Docket Item # 3
BAR CASE # 2017-00397

BAR Meeting
November 15, 2017

ISSUE: Alterations (shutters and fence)

LOCATION: 608 South Fairfax Street

Figure 1. Front (west) elevation of new dwelling, as constructed, without shutters.

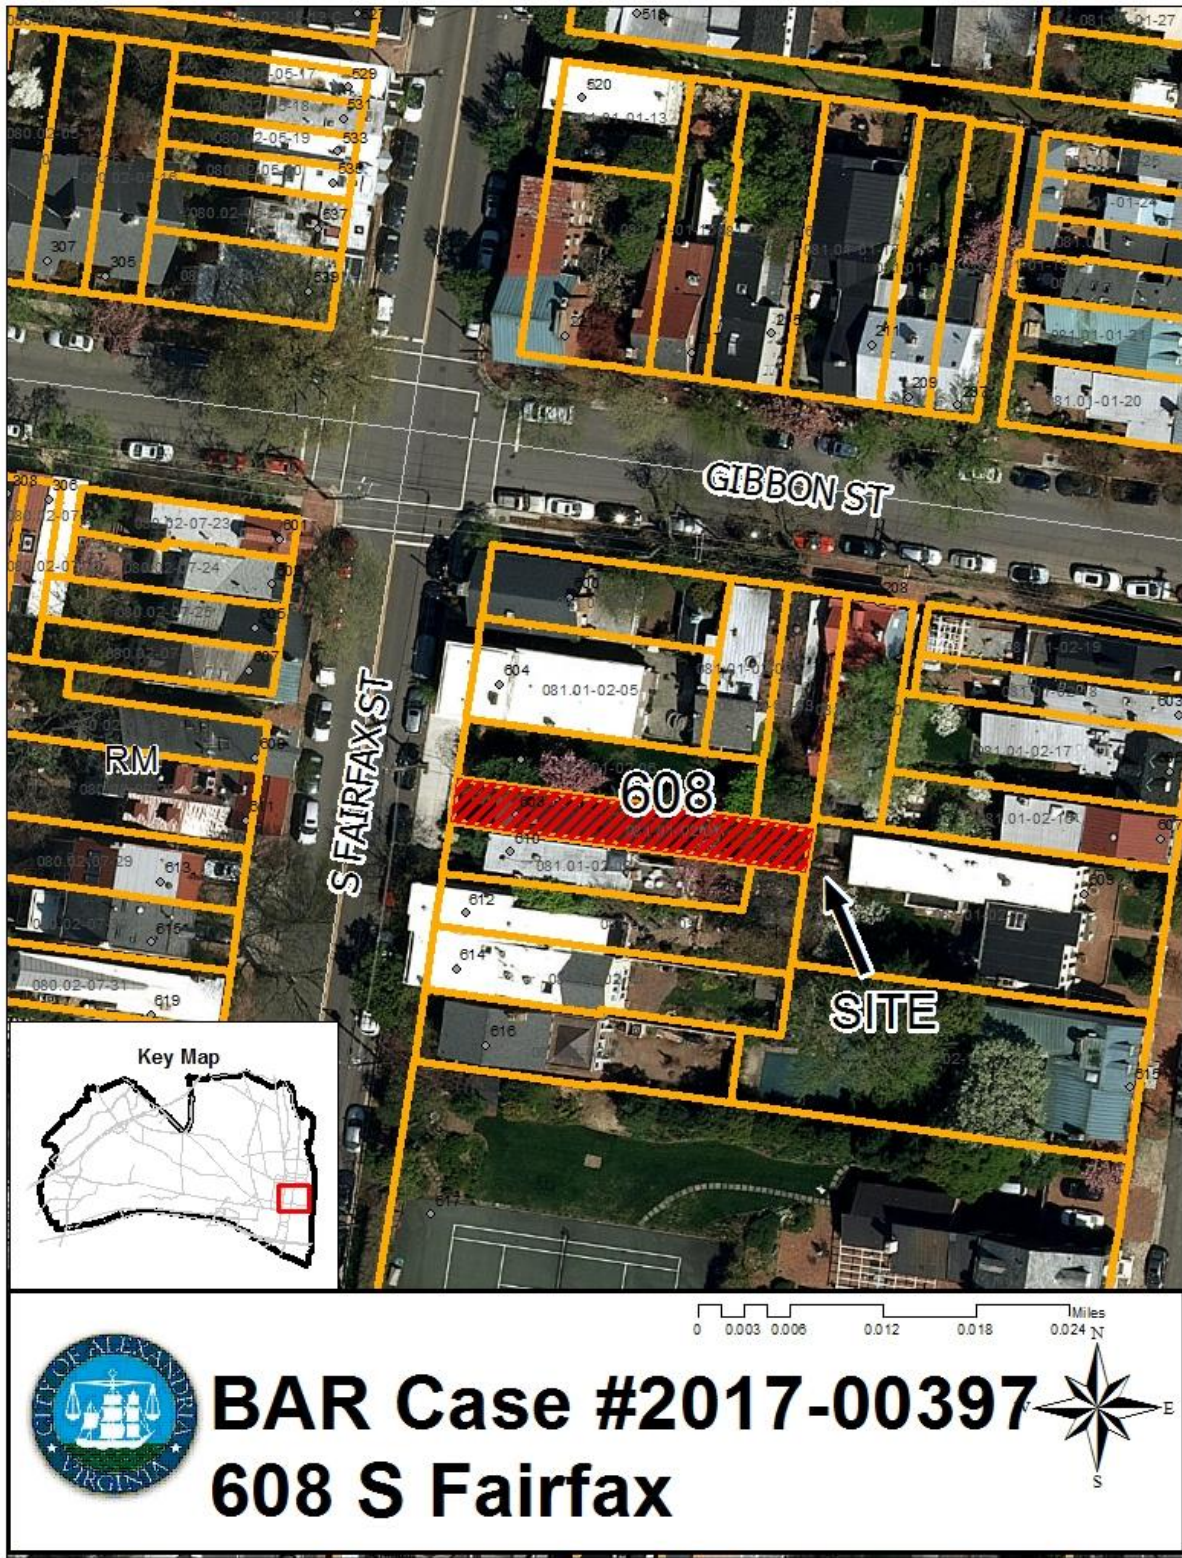
The applicant requests approval for the installation of operable shutters for the first and second floor windows on the front (west) elevation. The shutters will be constructed of solid through the core, millable, synthetic wood composite in a 20/40/40 configuration with operable steel hardware. Both the shutters and hardware will be painted black to match the entry door. The shutters are requested, in part, to conceal the electric meter and telephone connection hardware adjacent to the first-floor window. While building systems/utilities are necessary in modern construction, the applicant is hoping to reduce their visual impact/presence through concealment behind the requested shutters.

The proposed shutters refine the contemporary Federal-styled details on the new house at 608 South Fairfax Street, though the use of shutters was not historically reserved for high-style buildings and were a functional requirement to regulate weather and provide security and privacy prior to the 20th century. The simple window surround, as well as the progressively small window sizes flanked by shutters, are elements commonly seen throughout the historic district, though their use today is largely aesthetic rather than functional. Staff finds the shutters to be architecturally appropriate at this new dwelling. In this case, the shutters will also help to screen the meters placed by the utility companies at the north side of the front elevation. It should be also noted that shutters are a rather ephemeral building element which are commonly added or removed as they deteriorate and properties change hands over time.

Staff recommends approval of application for window shutters and a brick fence with a wrought iron gate, as submitted.

FRONT / WEST ELEVATION - EXISTING VS PROPOSED

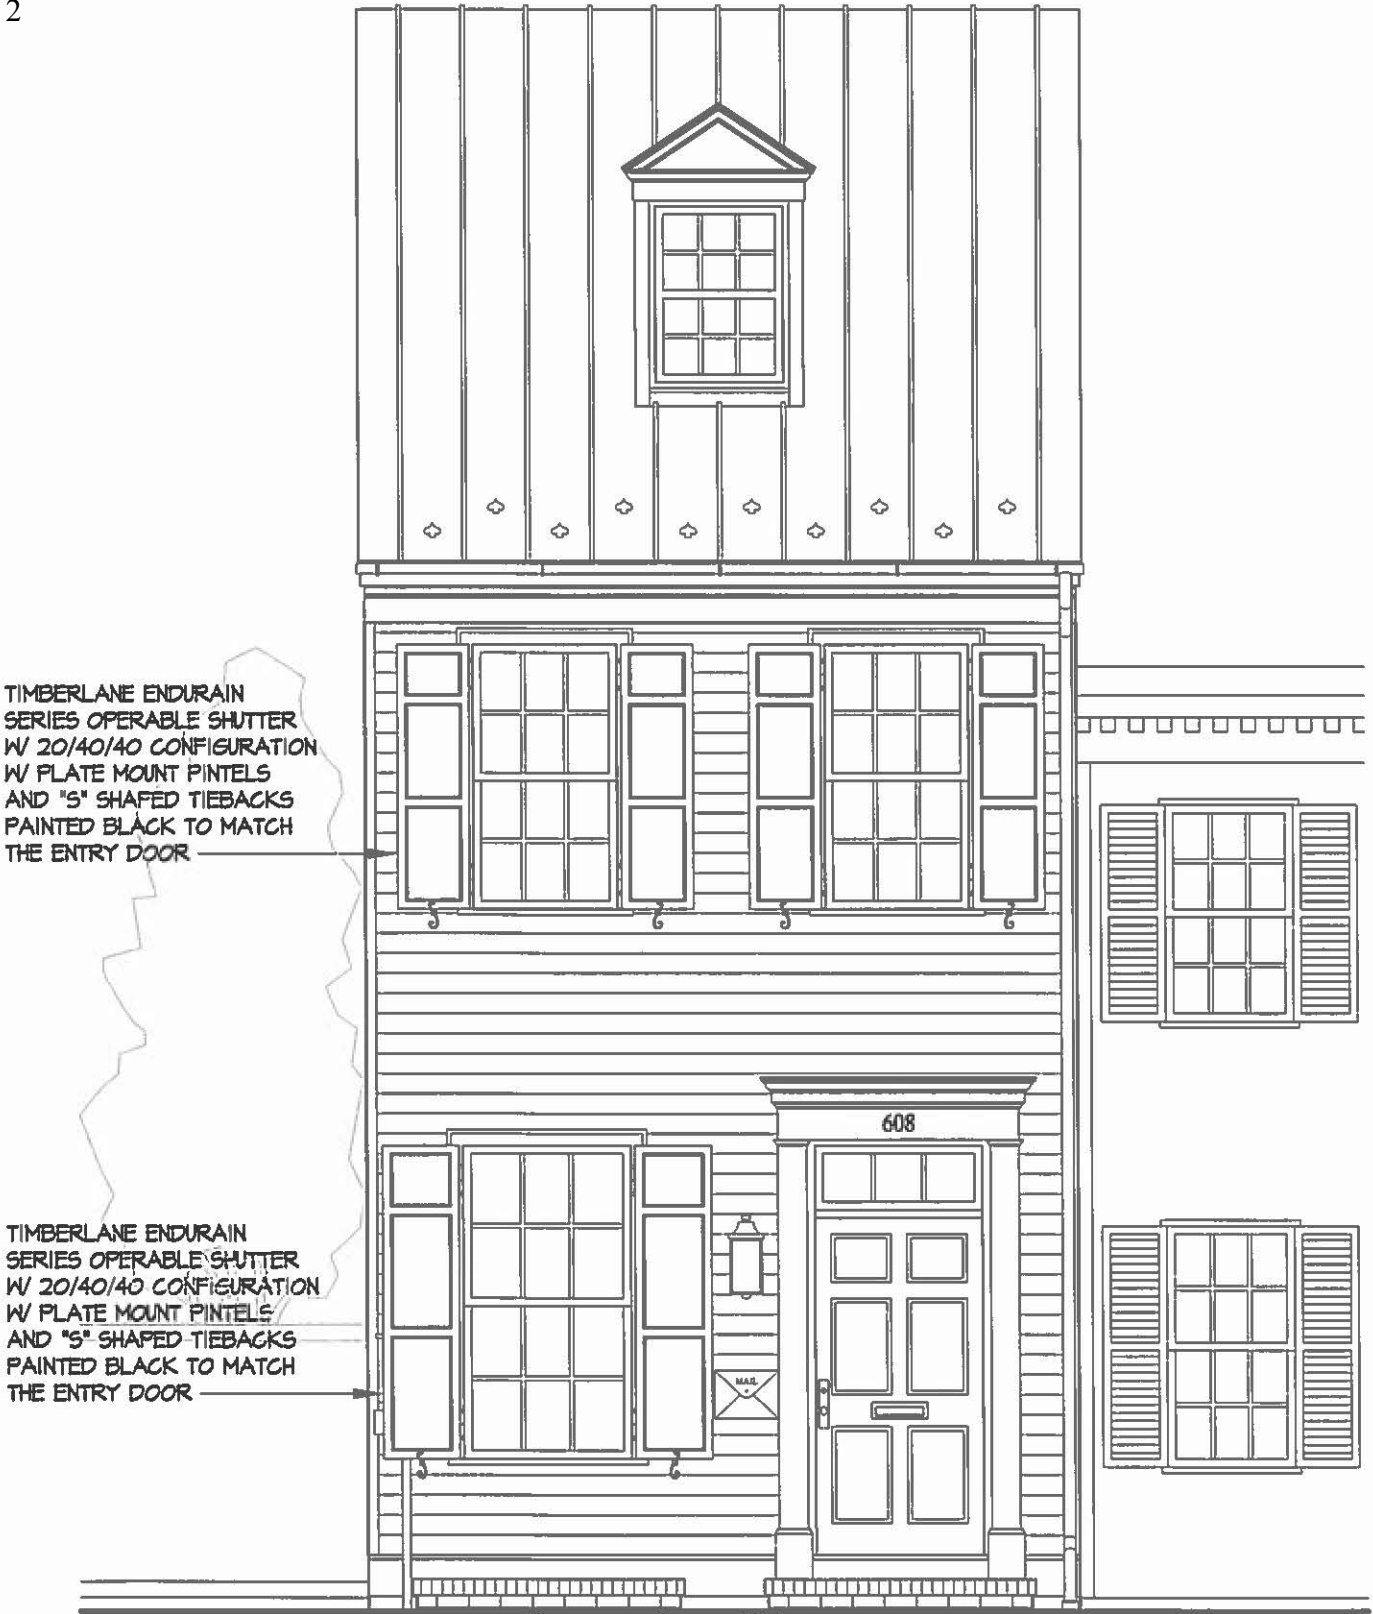
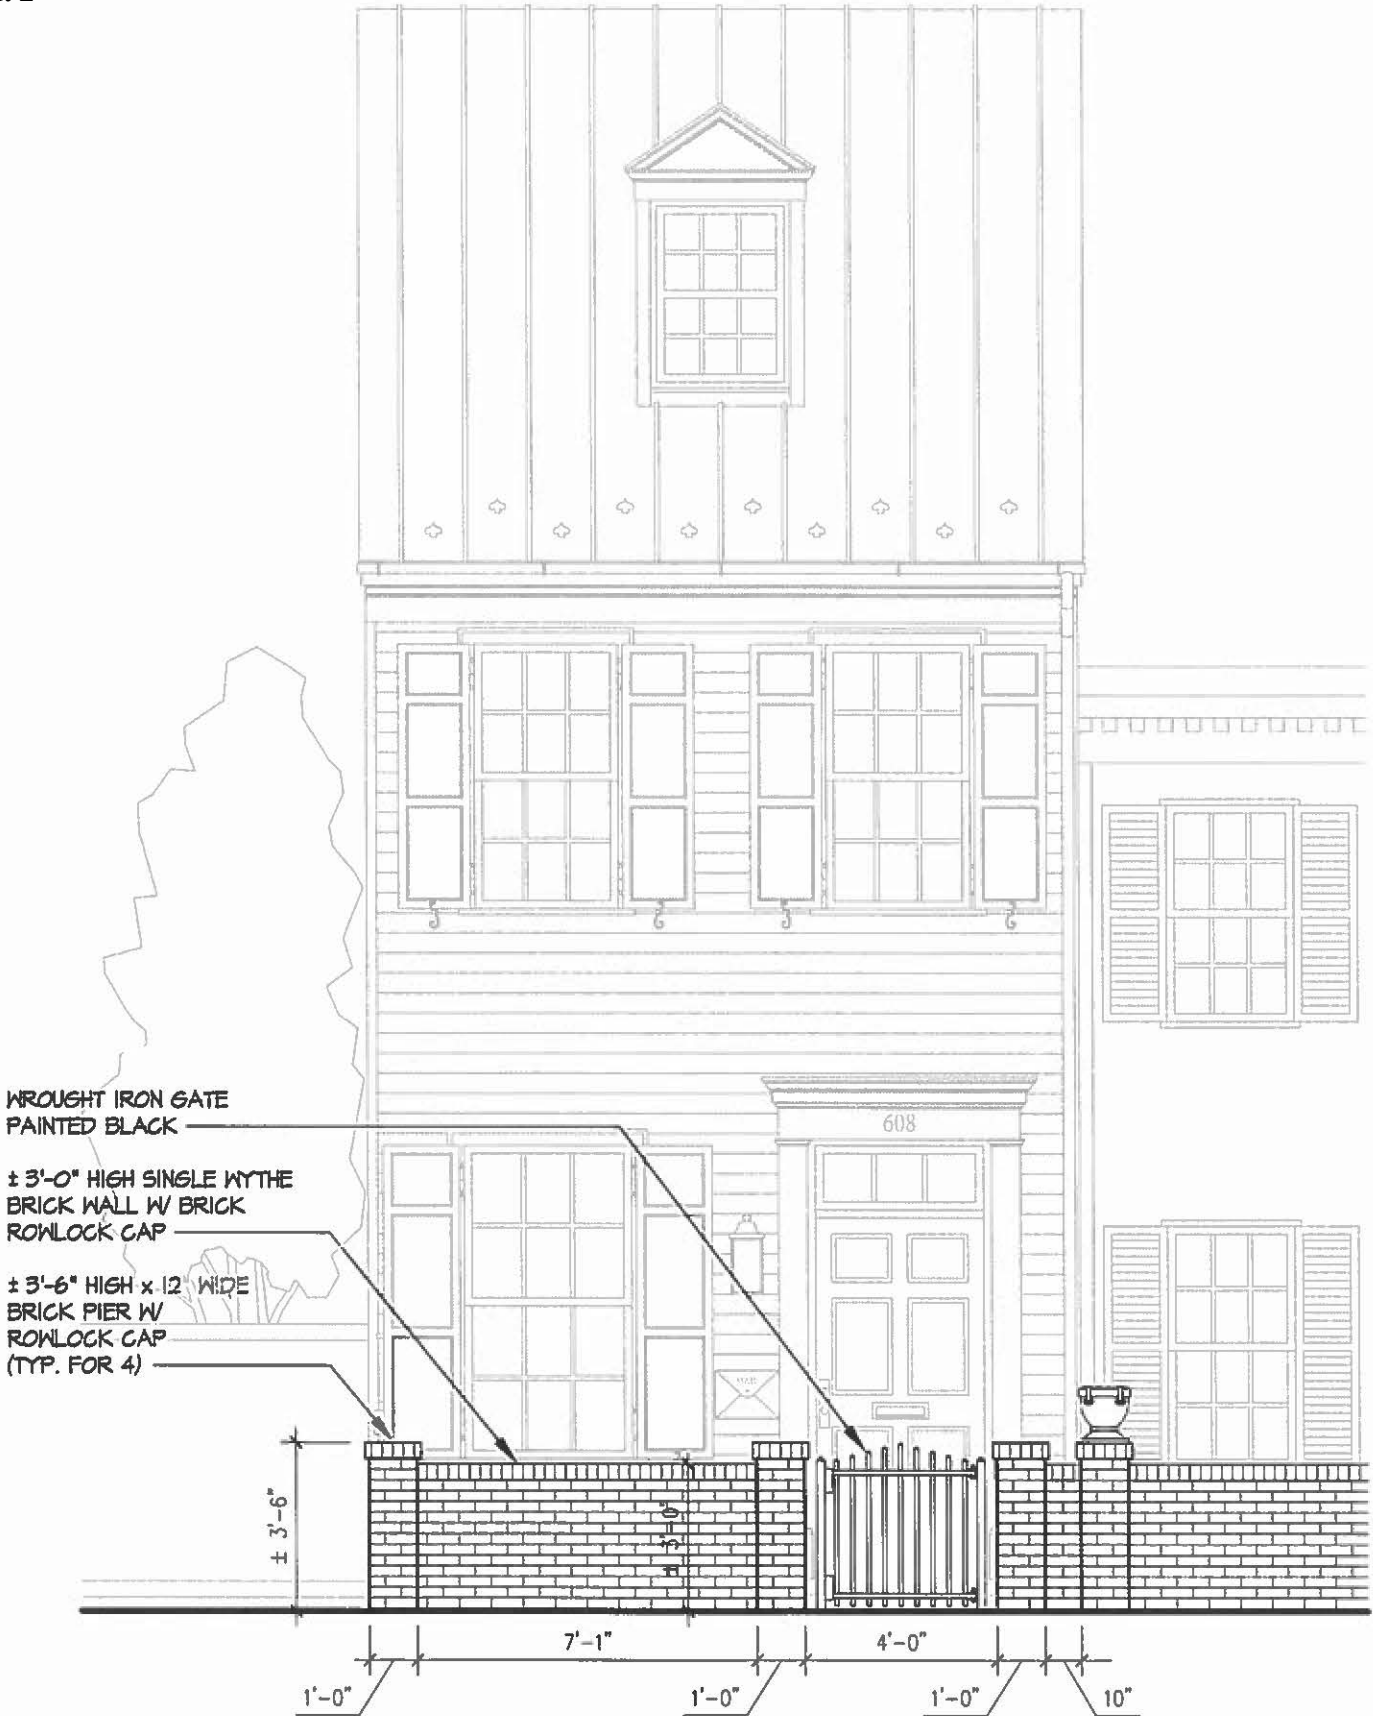
C-2 Proposed shutters installation complies with zoning.
